Application for Licence Amendment

Licence Number	L8675/2012/1
Licence Holder	Millennium Minerals Limited
ACN	003 257 556
File Number	DER2014/002927-1
Premises	<p>Nullagine Gold Operation – Golden Eagle Project</p> <p>Mining Tenements M46/3, M46/47, M46/50, M46/57, M46/64, M46/98, M46/129, M46/138, M46/146, M46/163, M46/164, M46/166, M46/167, M46/170, M46/182, M46/186, M46/187, M46/189, M46/192, M46/198, M46/199, M46/200, M46/225, M46/261, M46/262, M46/263, M46/264, M46/265, M46/266, M46/267, M46/272, M46/273, M46/274, M46/275, M46/276, M46/277, M46/278, M46/279, M46/282, M46/283, M46/300, M46/302, M46/303, M46/426, M46/427, M46/428, M46/429, M46/430, M46/431, M46/432, M46/433, M46/434, M46/436, M46/441, M46/442, M46/443, M46/444, M46/445, M46/446, M46/447, M46/448, G46/2, L46/33, L46/45, L46/88, L46/89, L46/90, L46/91, L46/92, L46/98, L46/105, L46/115, P46/1670, P46/1671, P46/1672, P46/1673, P46/1674, P46/1675, P46/1676, P46/1703, P46/1704, P46/1705, P46/1706, P46/1707, P46/1757, P46/1758, P46/1759, P46/1760, P46/1761, P46/1804, P46/1823, P46/1824, P46/1855, and P46/1856</p> <p>NULLAGINE WA 6758</p>

Date of Report	2 February 2021
Decision	Licence granted

Figure 1: Geochemical characterization of BC and NGP tailings.

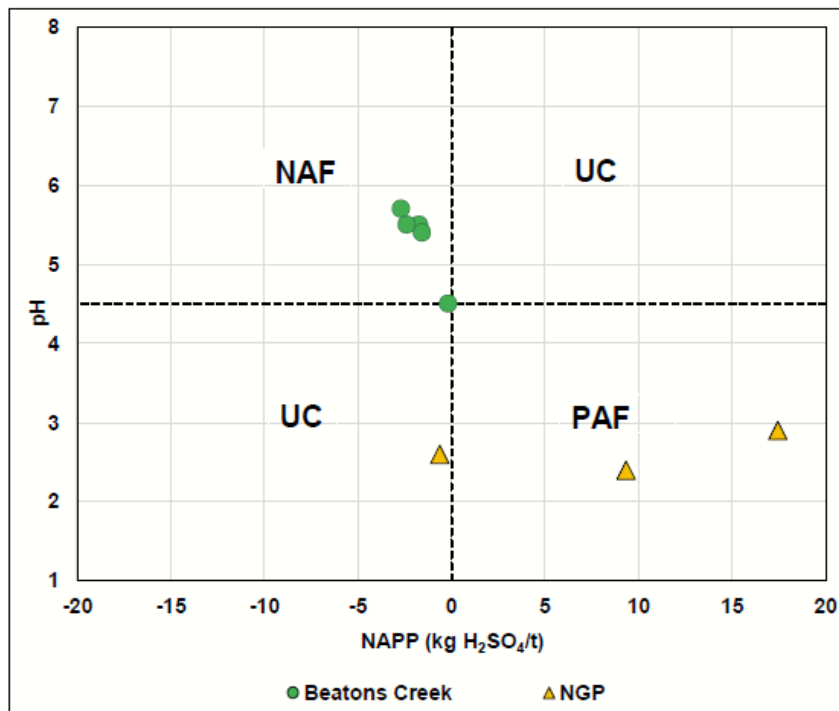
Based on the AMIRA (2002) classification criteria, three samples from BC are non acid forming and one is uncertain (Figure 1).

DWER has reviewed the geochemical differences between BC and NGP tailings and is of the view that all the enriched elements are already captured in the licence.

Figure 4: Sulphate concentration around TSF2.

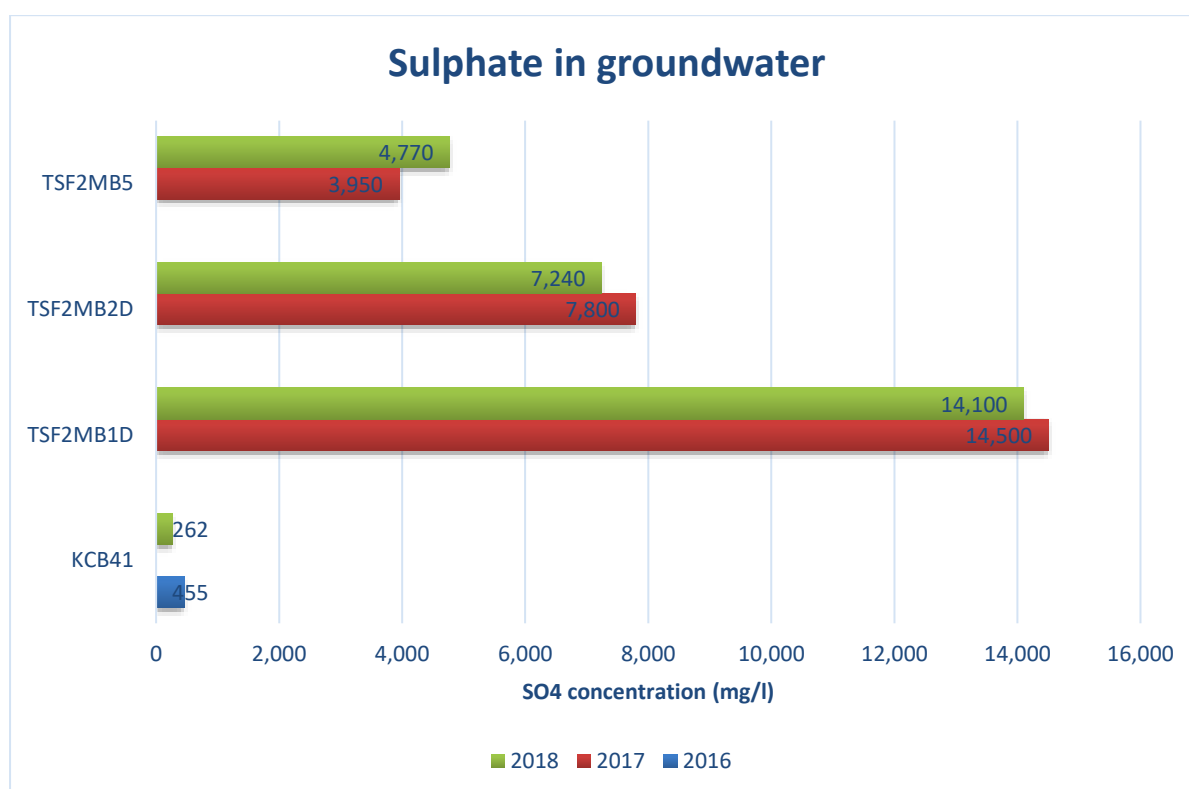
Groundwater results extracted from NGP Annual Groundwater Reports and Annual Environmental Reports show that discharge of tailings into TSF2 has had a detrimental effect on groundwater quality. Sulphate levels in groundwater around TSF2 is 12 times higher than KCB41 (upstream abstraction bore). TSF2 MB5, located 1.3 km downstream of TSF2MB1, shows sulphate concentration 3.5 times lower (4,140 mg/l) than TSF2MB1 but 46 times higher than KCB41. A summary of sulphate concentration in groundwater around TSF2 is presented in Figure 5.

Based on monitoring results and the fact that TSF2 was built without an impermeable layer, DWER will require a seepage management plan for TSF2 (condition 4.1), inclusion of recovery bores TSFB002 and TSFB003 to the licence (Table 1.2.7) and introduction of surface water level trigger level to prevent vegetation death, further deterioration of groundwater quality and expansion of contaminant plume (Table 3.3.1).

Figure 5: Monthly groundwater elevations around TSF2.

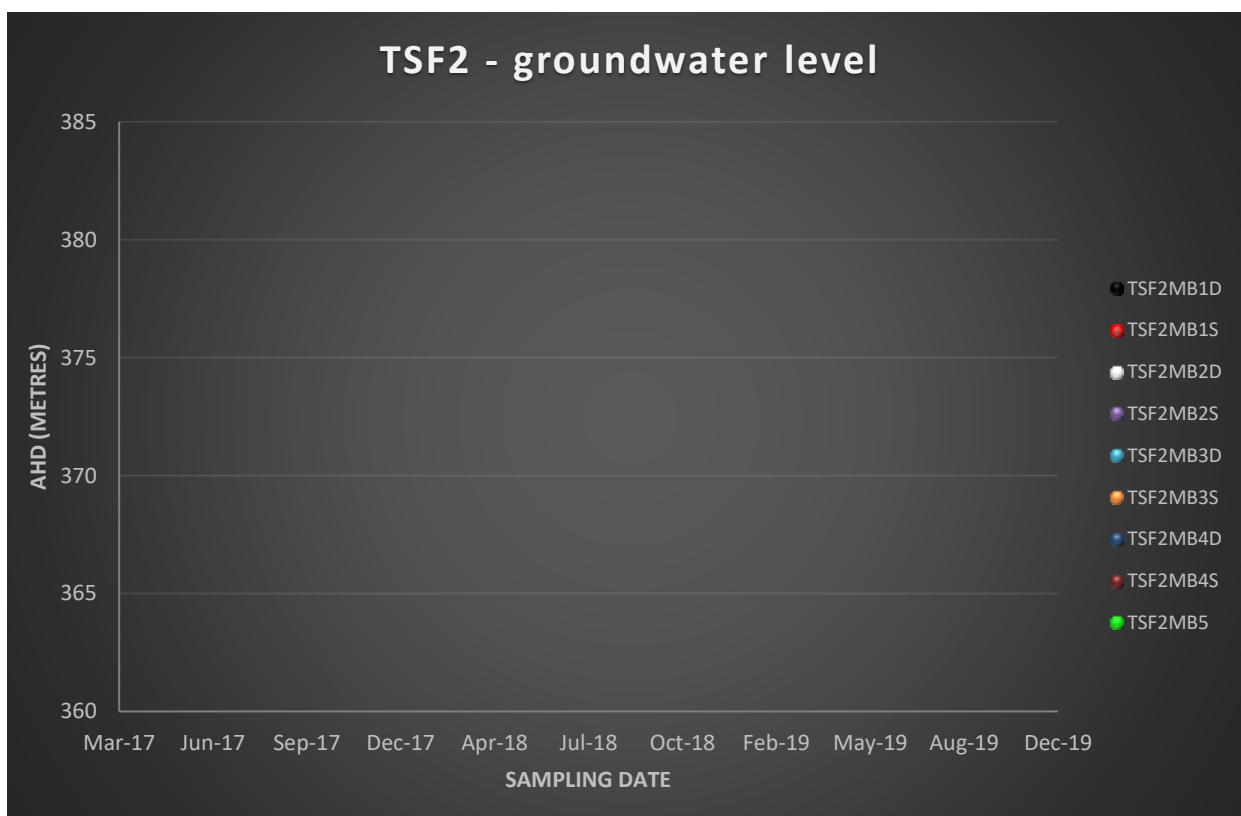
Groundwater level at TSF2 monitoring bores TSF2MB1, TSF2MB2D and TSF2MB2D show direct correlation of tailings discharge and rise in surface water level. Surface water level behavior around TSF2, between March 2017 and August 2019, is depicted in Figure 5.

The low recovery levels are reflected in the increase of surface water level in monitoring bores presented in Figure 5.

Figure 6: Water movement in TSF2 between 2017 and 2018.

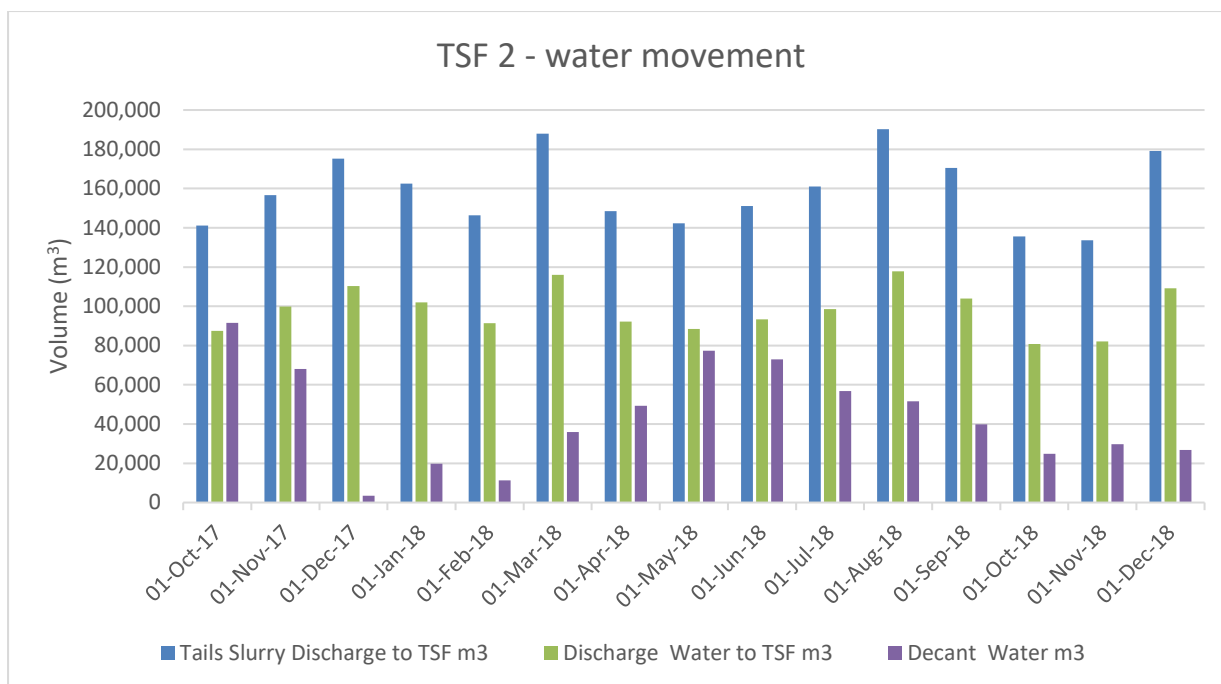
Figure 6 shows TSF2 water management between 2017 and 2018. Decant recovery is not consistent during the reported period. In December 2017 only 3% of the total water discharge was recovered in the decant. The average water recovery during the period was 41%.

DWER understands that changes in the decant system may improve recovery but the new design is yet to be tested.
